ADDENDUM DRAWING ADD-013.1
JOB NUMBER 2002480
DATE 1-8-2008

MODERNIZATION AT CURRAN MIDDLE SCHOOL FOR:

SHEET TITLE
SITE PLAN

SHEET IDENTIFICATION NUMBER
ADD-A-111
SHEET 02 OF 46

B1 SITE PLAN
1"= 40'-0" 0' 20' 40' 80'

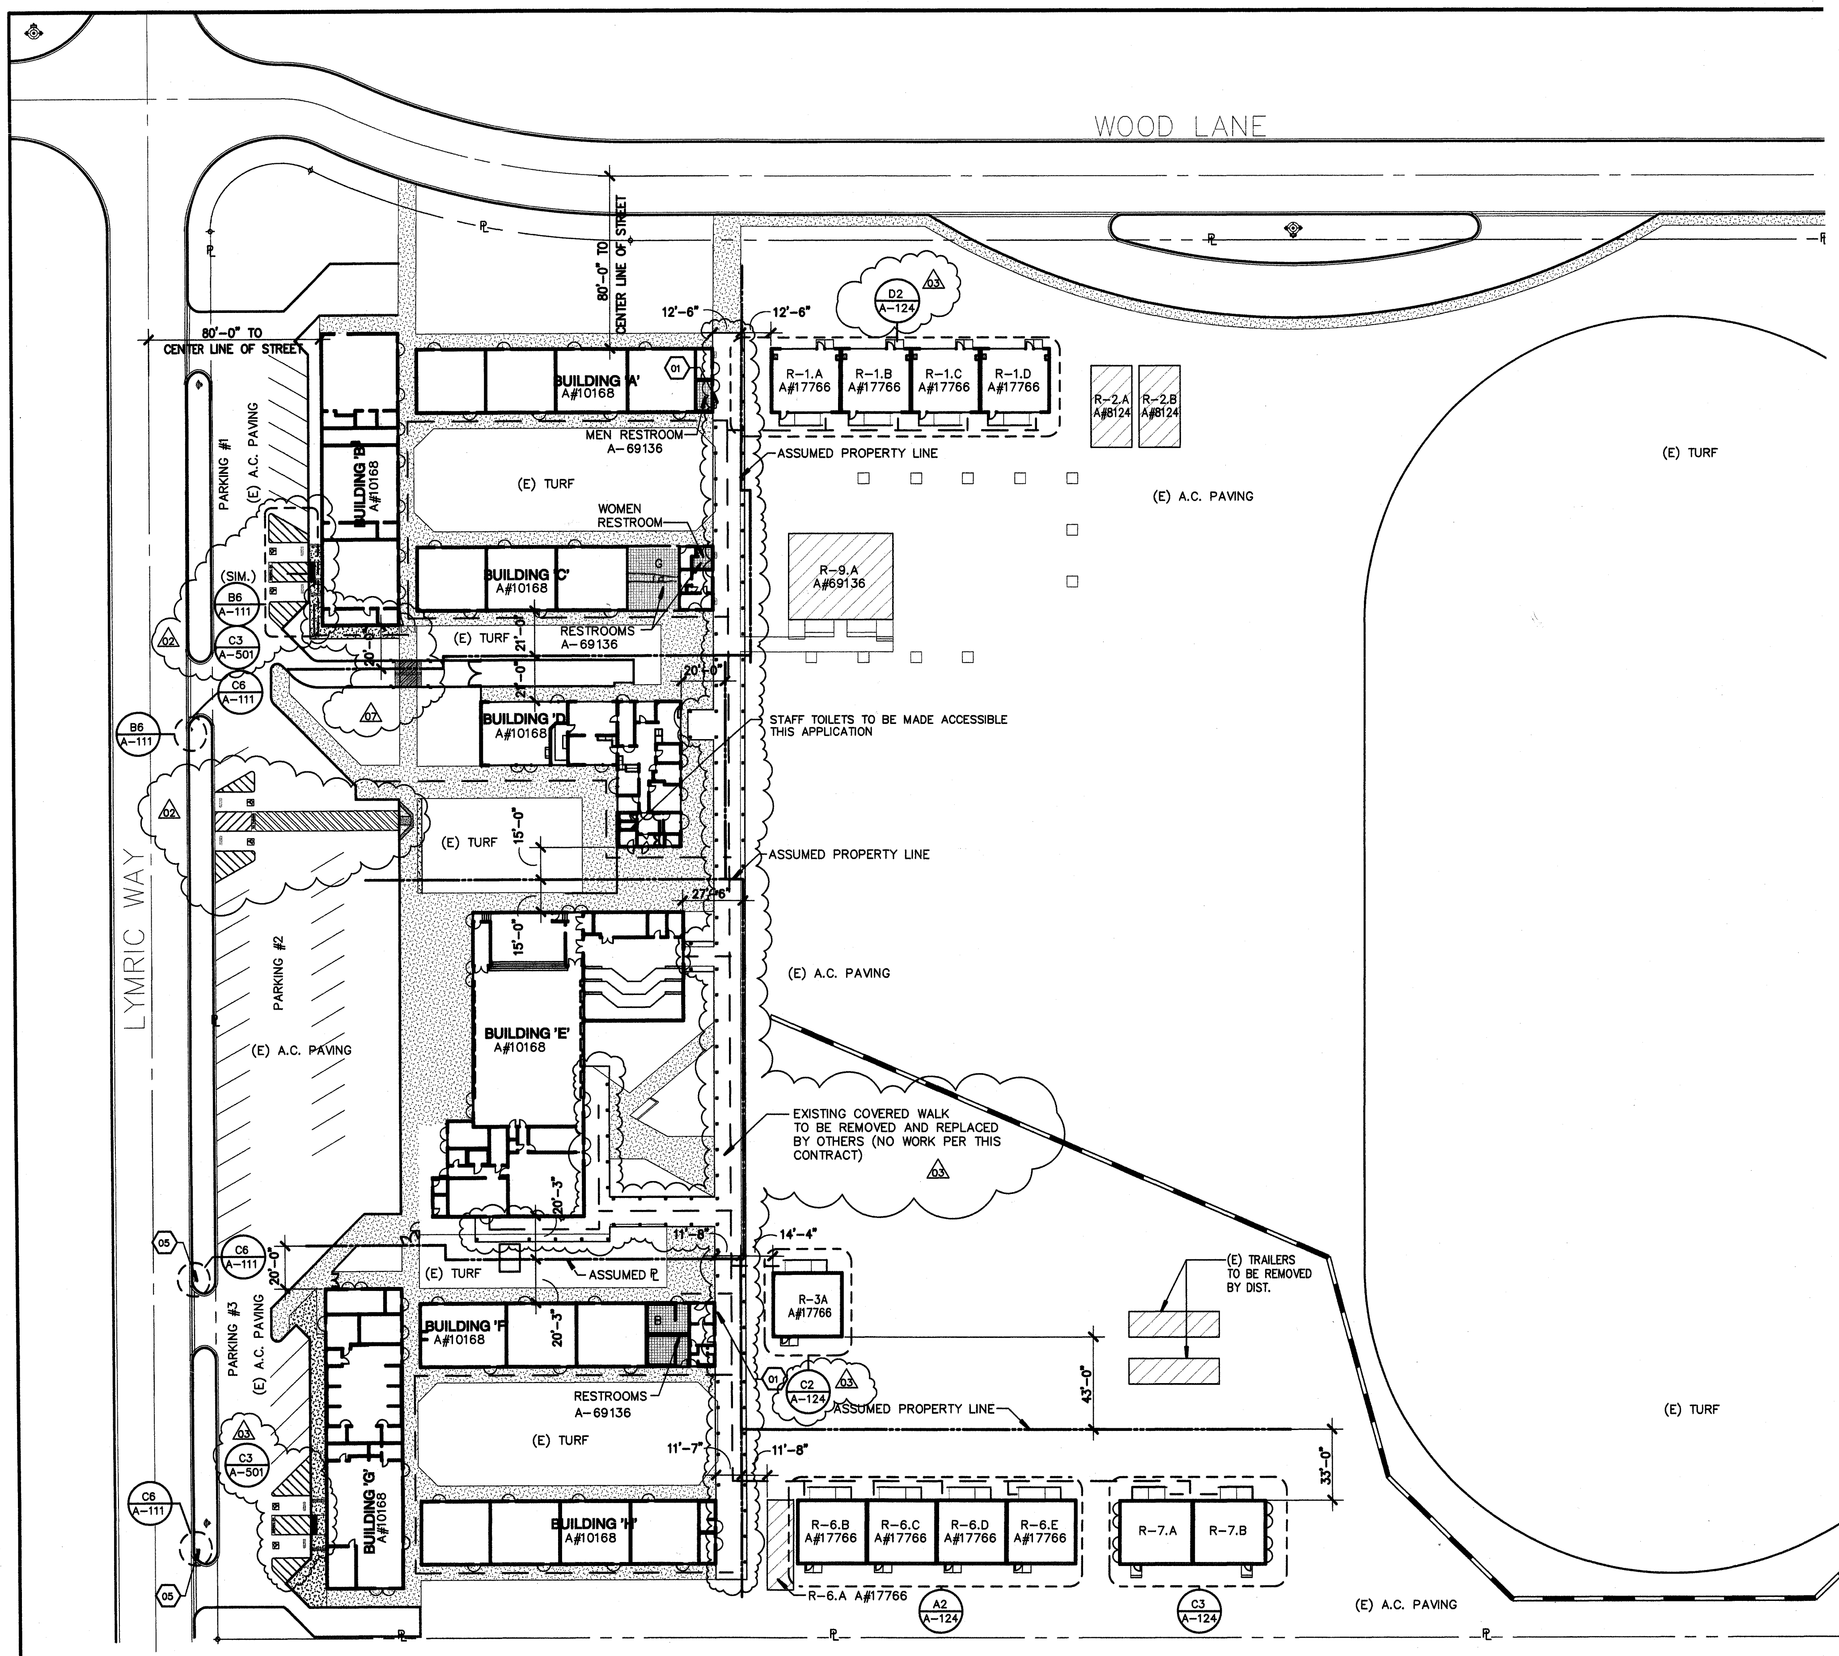
Item No. 1: Refer to Sheet A-111 – Parking lot #1 accessible parking stalls to be revised per addendum drawing ADD-002
ADD # 2
Item No. 2: Refer to Sheet A-111 – Parking lot #2 accessible parking stalls and crosswalk to be revised per addendum drawing ADD-003
ADD # 2
Item No. 3: Refer to Sheet A-111 – Parking lot #3 accessible parking stalls to be revised per addendum drawing ADD-004
ADD # 2

Item No. 7: Refer to Sheet A-111
ADD # 2 Enlarged plan indicator D1/A-124 incorrect. Revise to read D2/A-124, Key Note #1 Reference to detail D4 incorrect revise to read C4, Keynote #3reference to detail B6/A-111 incorrect revise to read C3/A-501.

Item No. 1: Refer to Sheet A-111
ADD #7 Replace Sheet A-111 with Sheet ADD-A-111. Accessible path of travel between parking lots #1 and #2 revised per Addendum Drawing ADD-013 and ADD-013.1

D6 ACCESSIBLE D.F.

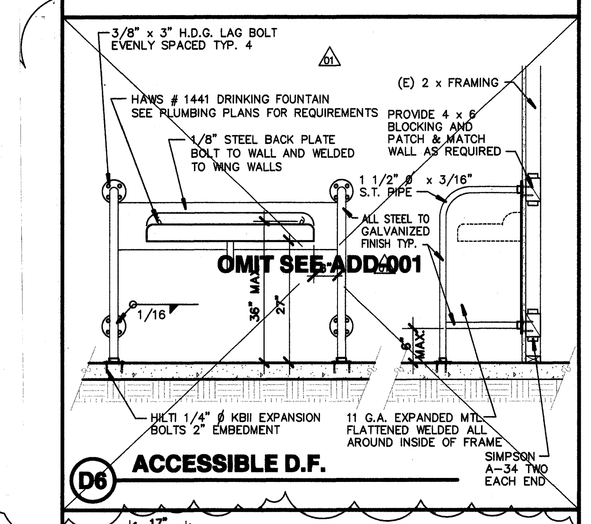
Item No. 1: Refer to Sheet A-111 – Detail D6 Accessible Drinking Fountain to be replaced with Hi-Lo Drinking fountain per Addendum Drawing ADD-001
ADD #1
